Re: Belmont Public Library – Design and Site Plan Review Application, Supplemental Information #2

Belmont Public Library

Design and Site Plan Review

**SUPPLEMENTAL INFORMATION
FOR OCTOBER 3, 2023 HEARING**

2. WELLINGTON BROOK FLOODWAY

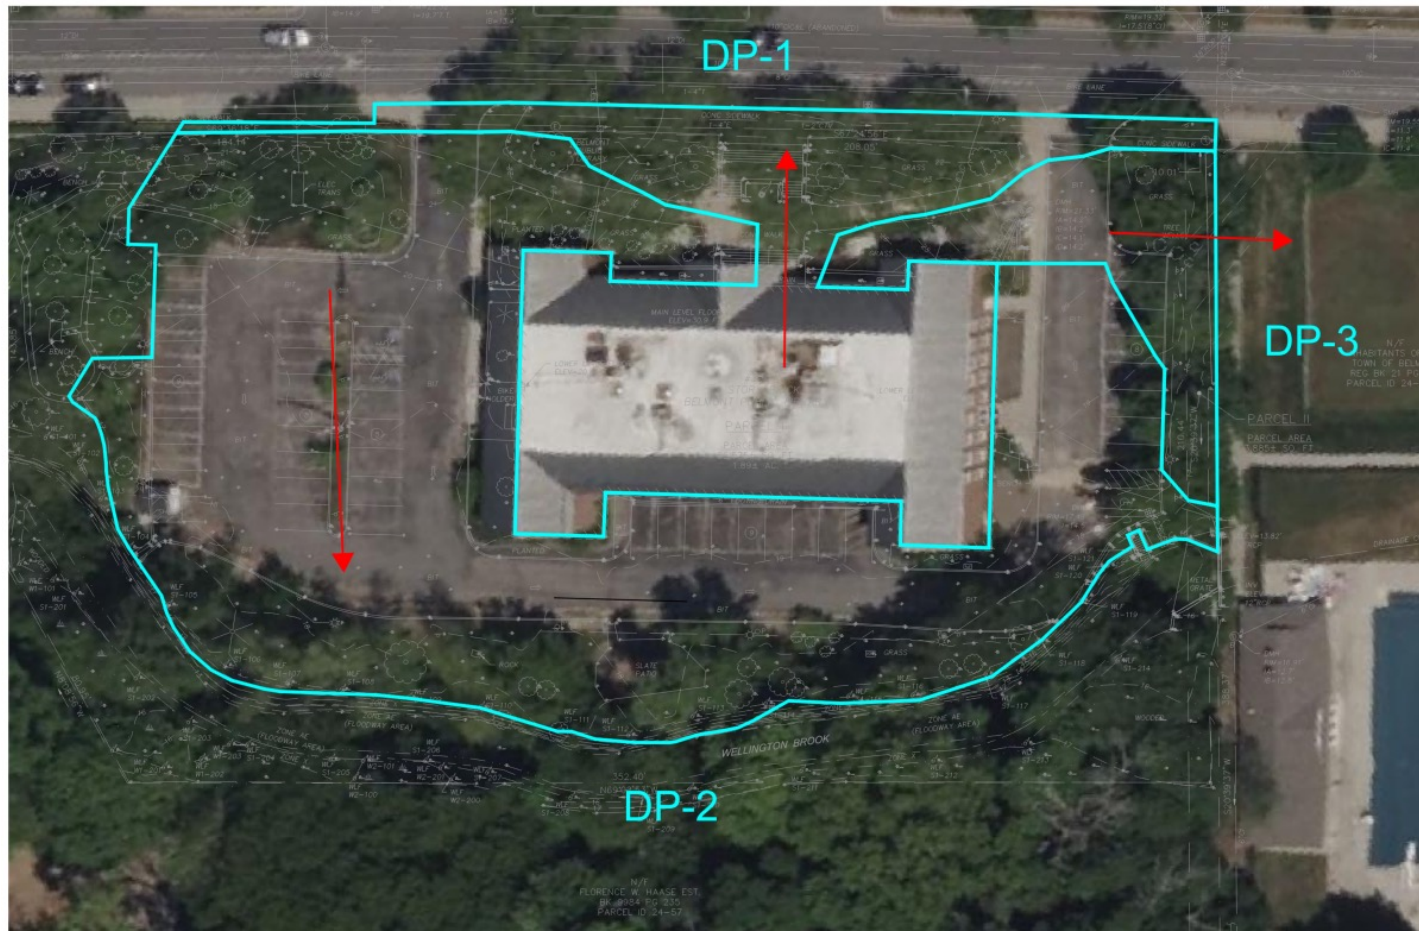
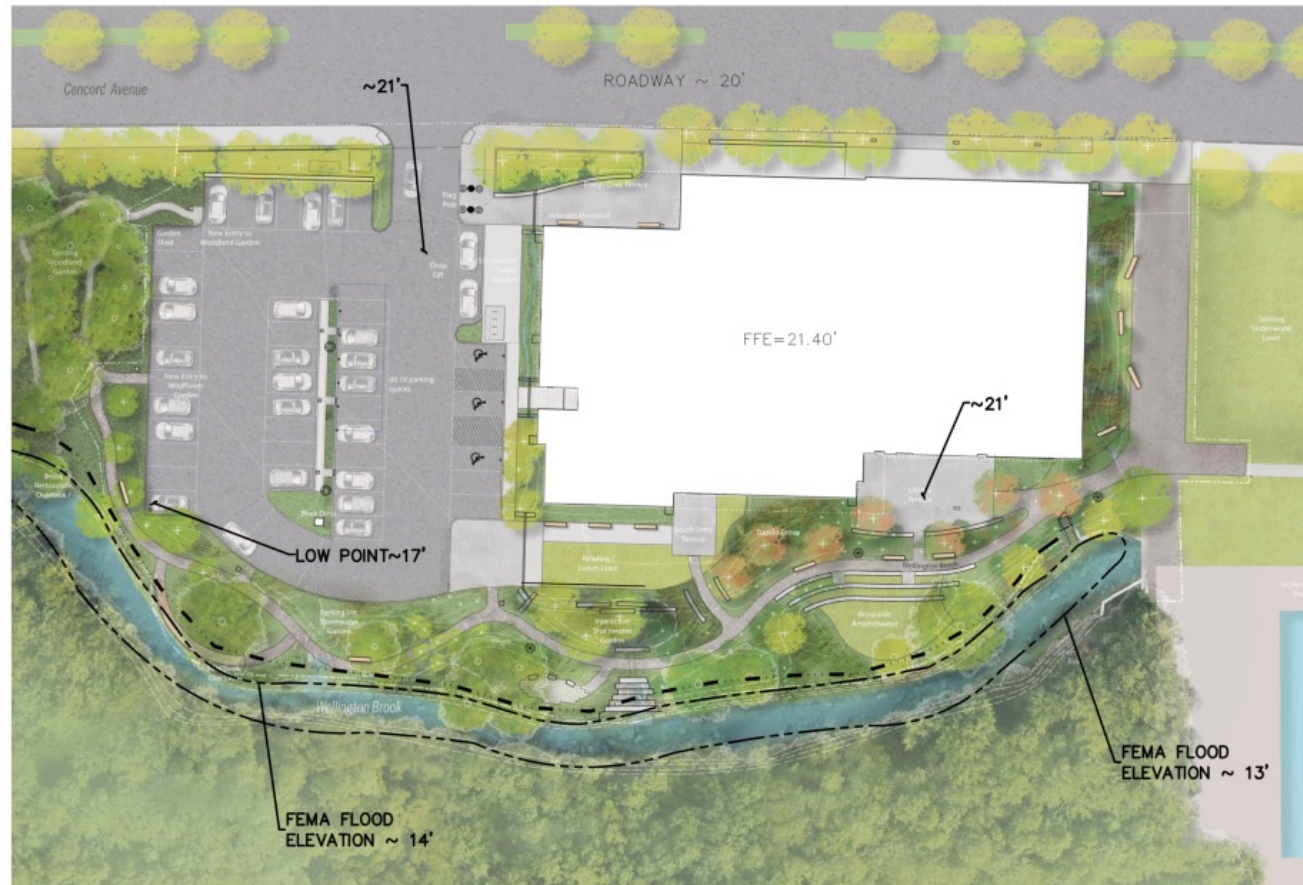
The new library building is located outside the Wellington Brook FEMA floodway (Zone AE. The proposed ground floor elevation of +21.4' is approximately 7' higher than the FEMA base flood elevation of +14.0'. Truck access is provided to the existing culvert to allow regular maintenance and cleaning of the culvert in coordination with DPW.

Please refer to the enclosed stormwater diagrams prepared by Nitsch Engineering (dated September 27, 2023) indicating proposed drainage areas and grade elevations.

Site Photometric Report

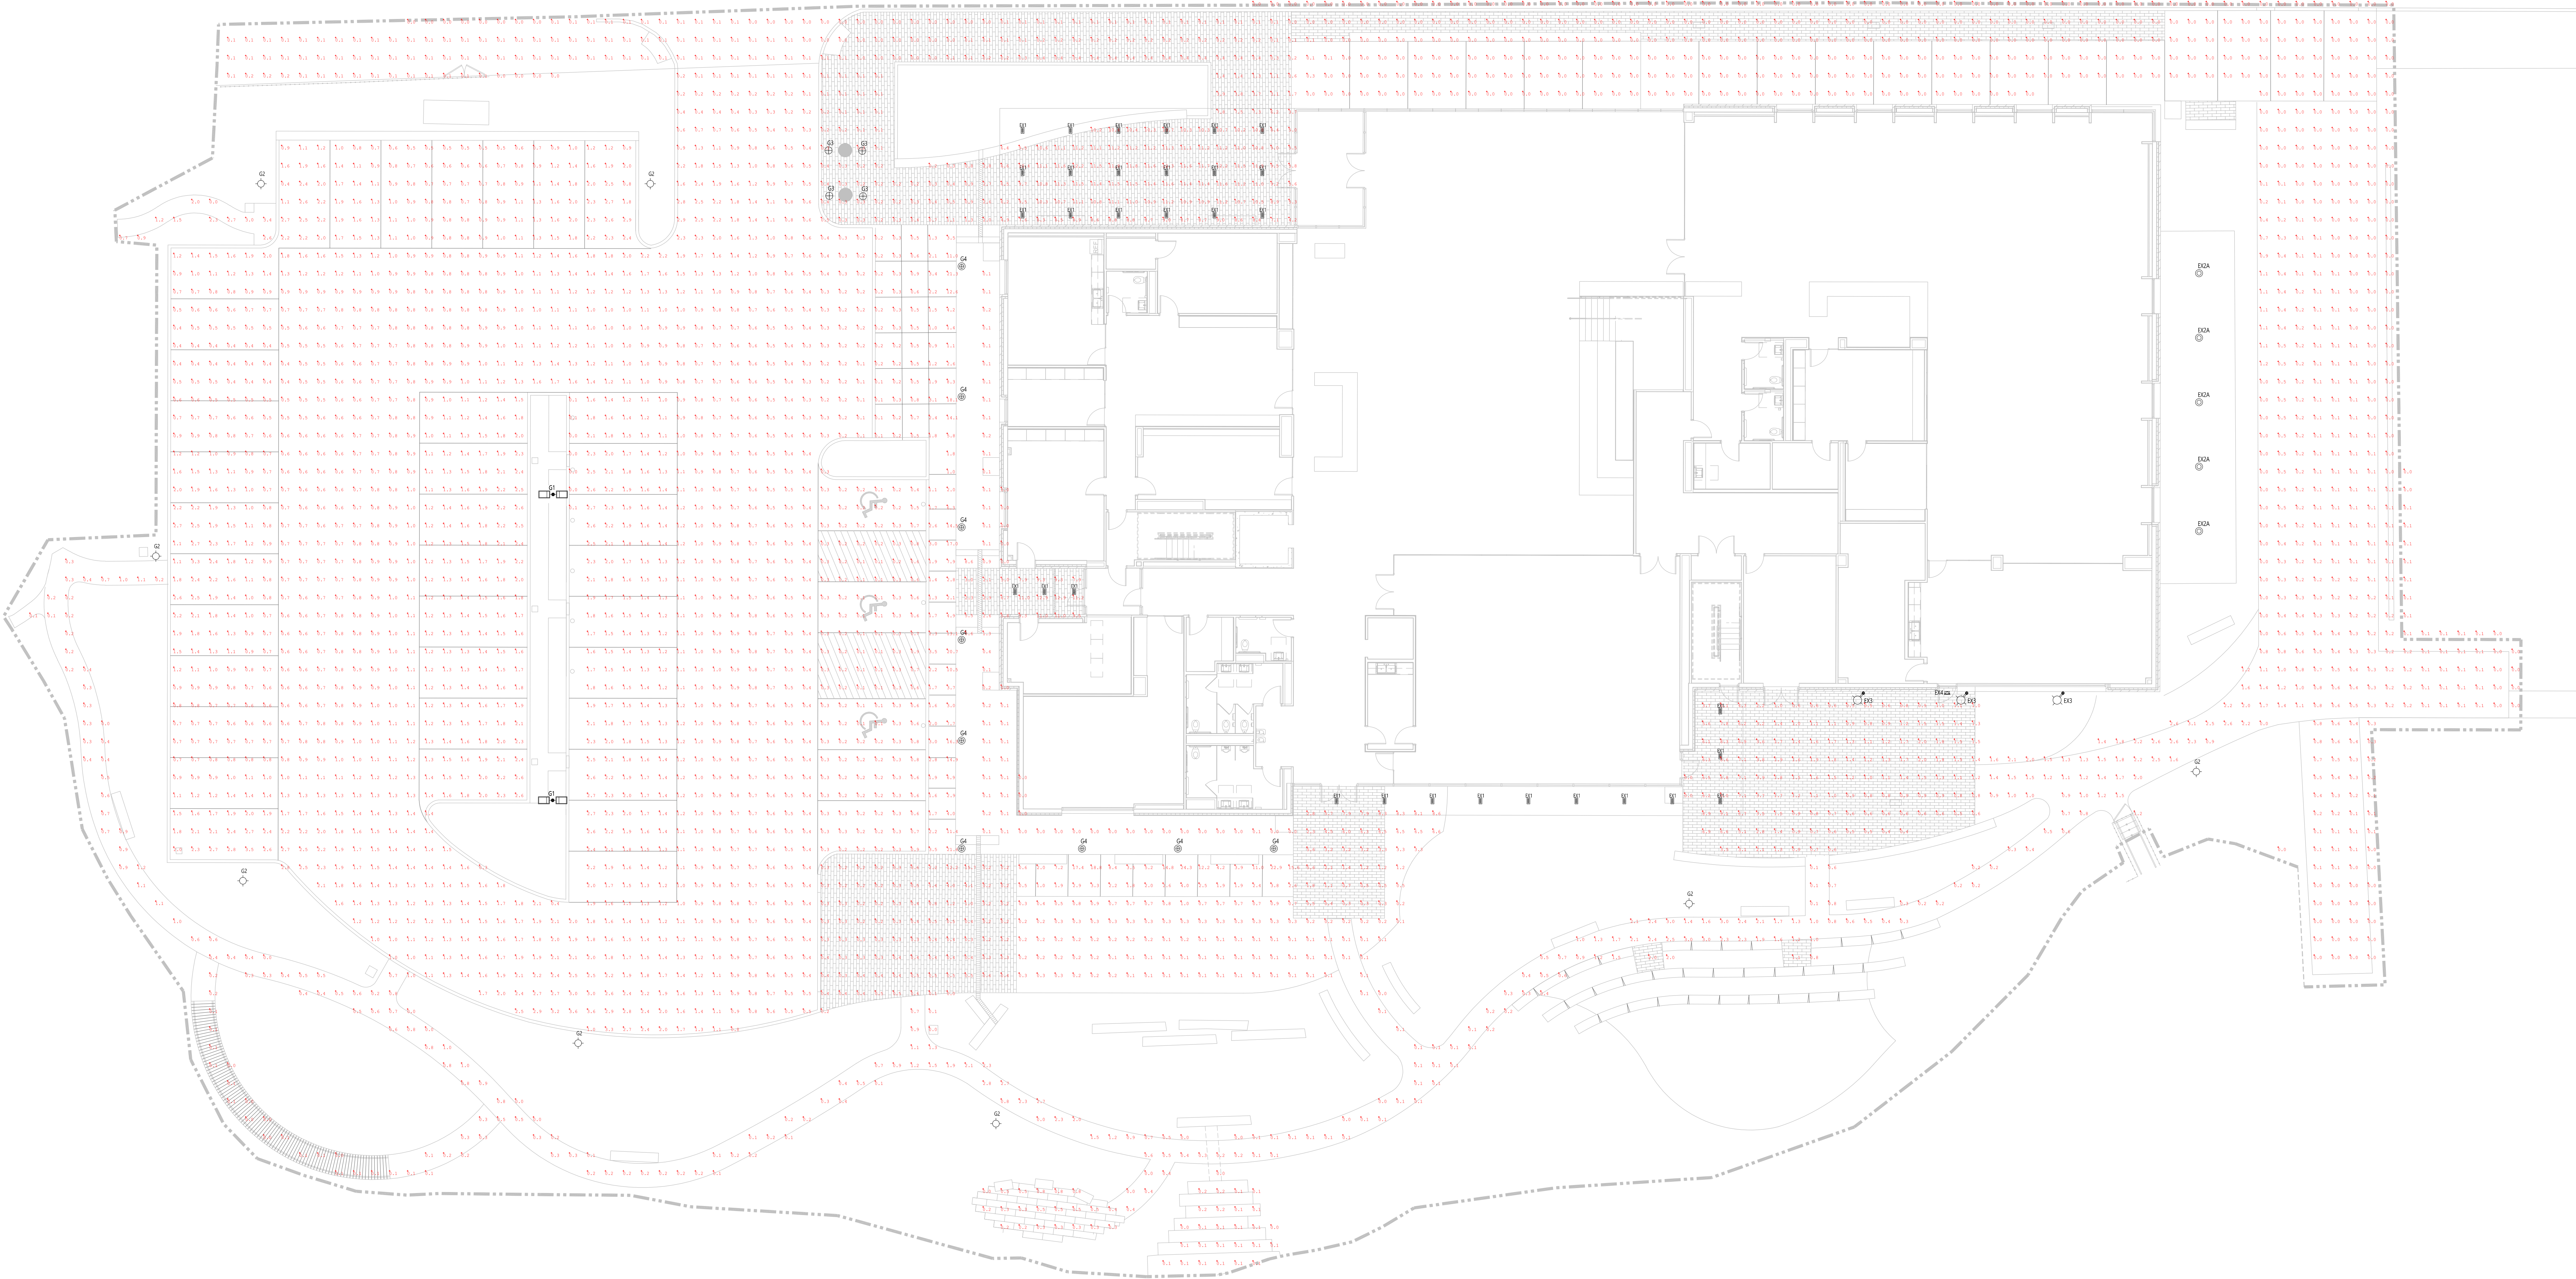
The revised exterior lighting plan and Site Photometric Report are submitted for record. The Site Photometric Plan supercedes the plan dated August 29, 2023. Exterior lighting is designed to meet the requirements of Section 5.4.3 of the Zoning By-Law.

Please refer to the enclosed exterior lighting plan and Site Photometric Report prepared by HLB Lighting (dated September 27, 2023).
